DEPARTMENT OF THE ARMY
HEADQUARTERS, UNITED STATES ARMY GARRISON, HAWAII
DIRECTORATE OF PUBLIC WORKS
947 WRIGHT AVENUE, WHEELER ARMY AIRFIELD
SCHOFIELD BARRACKS, HAWAII 96857-5013

This letter in concurrence with the enclosed report is in response to the State of Hawaii, Department of Health, Safe Drinking Water Branch Report of Sanitary Survey dated November 30, 2016, for the survey of the Aliamanu water system (PWS 337) conducted on October 26, 2016.

U.S. Army Garrison, Hawaii
DOH Sanitation Survey Aliamanu
Public Water System #337 Official Findings
November 30, 2016*

SUBJECT: REPORT OF SANITARY SURVEY
PUBLIC WATER SYSTEM NO. 337, ALIAMANU

AMR 2070 Middle Tank

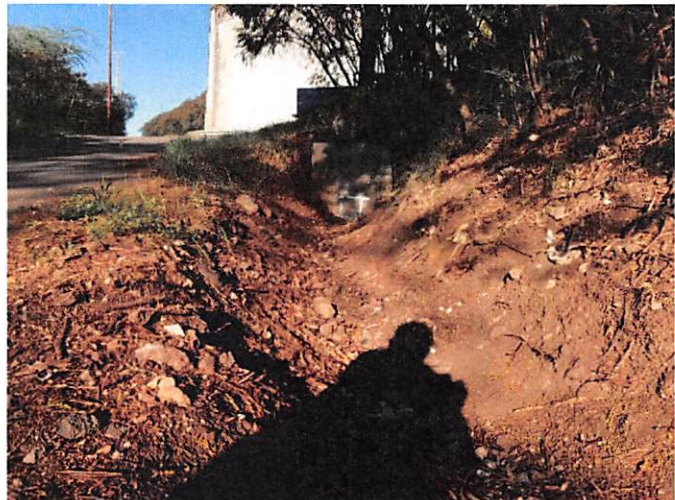
- **Recommendation #1:** Repair the potential spalling spots and the exposed rebar. Remove the vegetation on the tank exterior. **IN PROGRESS:** Facilities Engineering Work Request (FEWR) submitted for project completion, possible FY18 funding.
